Preliminary Drainage Report

For the Dos Lagos Lot 'E'
Parcel Number: 0419106028
405 39th Ave SE
Puyallup, Washington

May 2021
Revised August 2023
Revised March 2024
Job No: 12896

Project Name: Dos Lagos Lot ‘E’ Project

Basin Maps

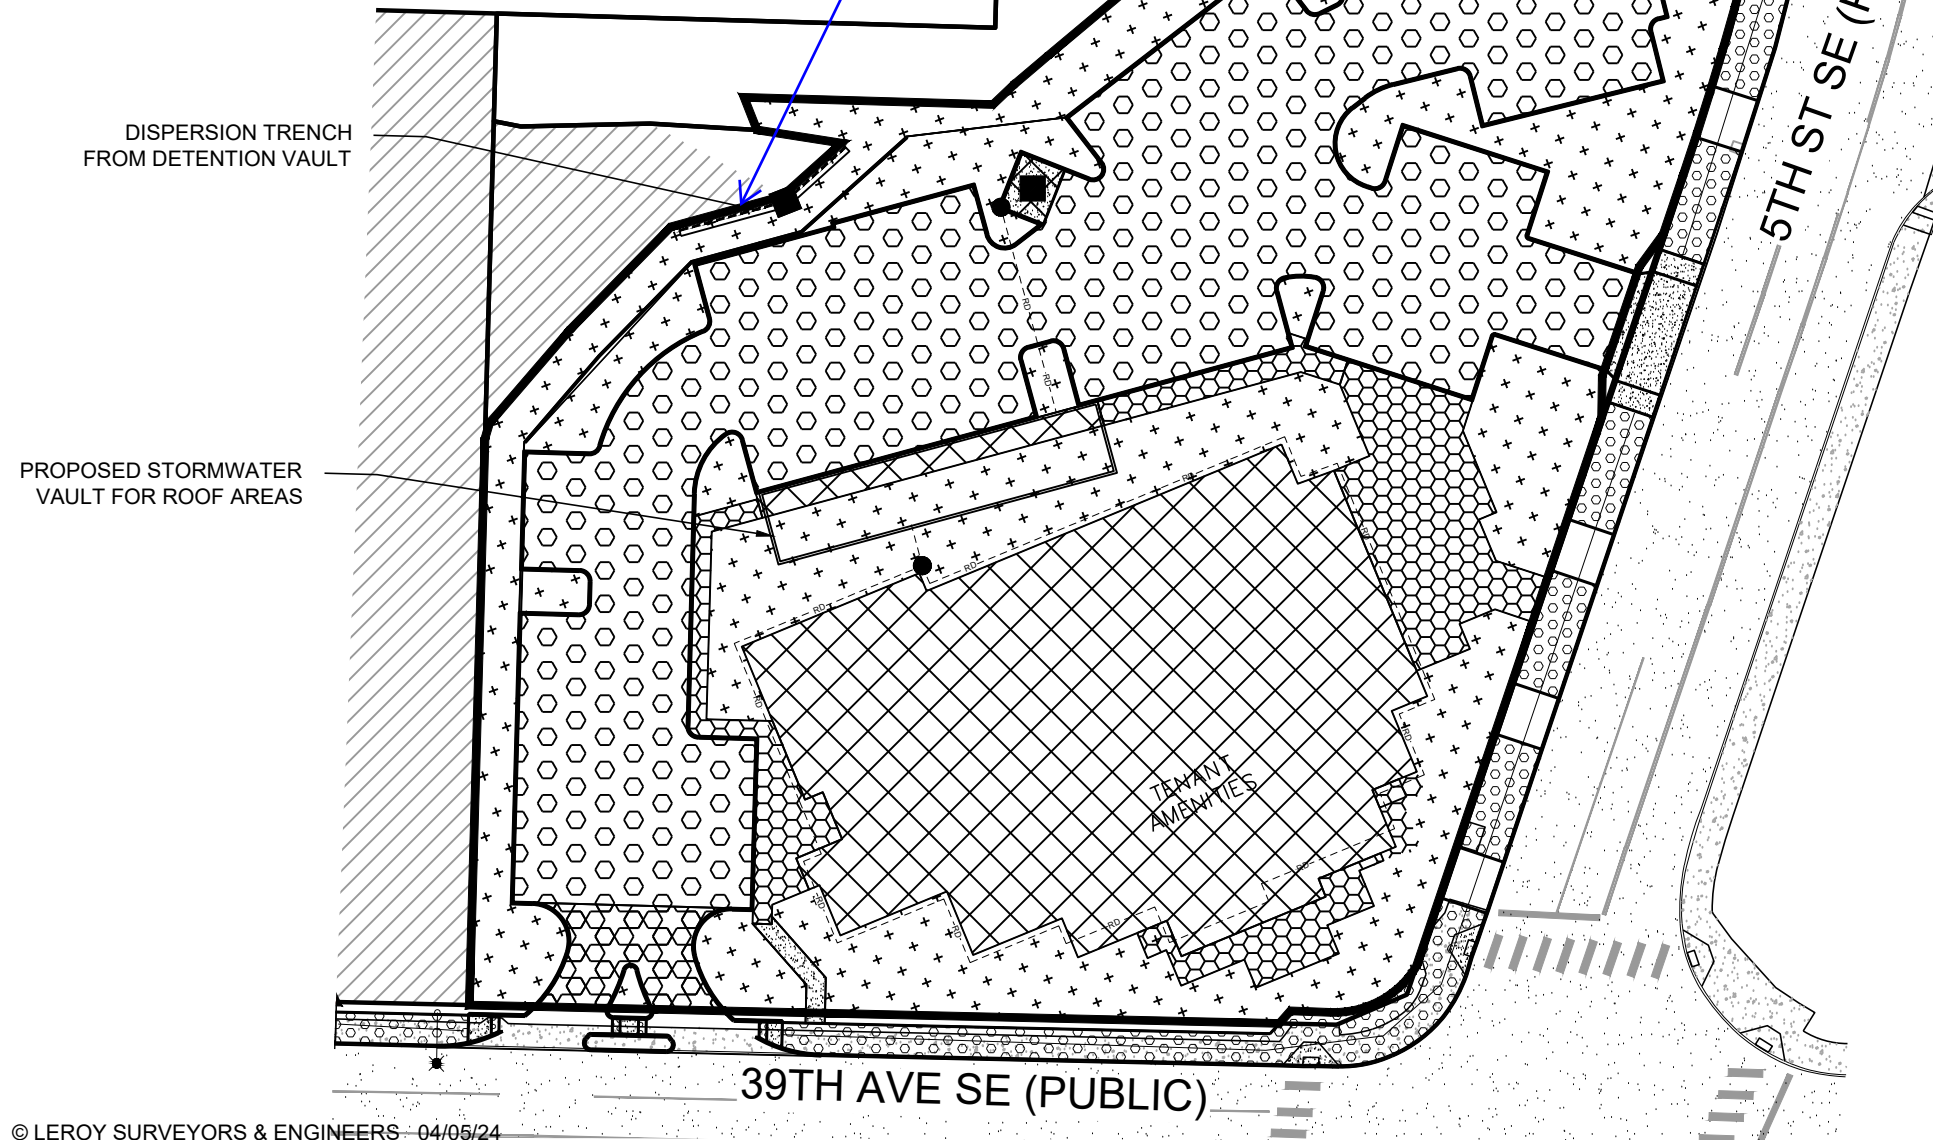
CONDITION: At time of civil, identify seasonal high groundwater elevation to ensure no impact to the dispersal trench.
